Rezoning Transportation Analysis

Petition Number: #2022-109

Date	Description
11-28-22	First Review (IW)

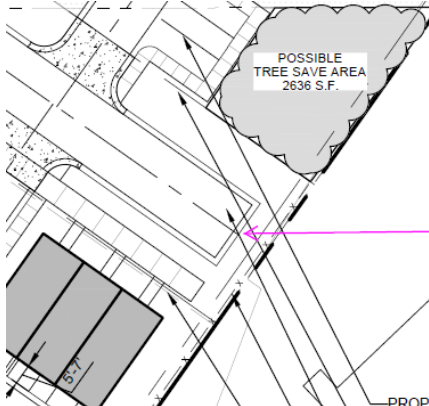
1. **Curbline:** The proposed zoning district has a setback measured from back of the existing or proposed future curbline.
 - a. **Plainfield Drive:** The future location of curb and gutter is in its existing location.

Label and dimension the curb and gutter from the centerline for each road on the site plan.
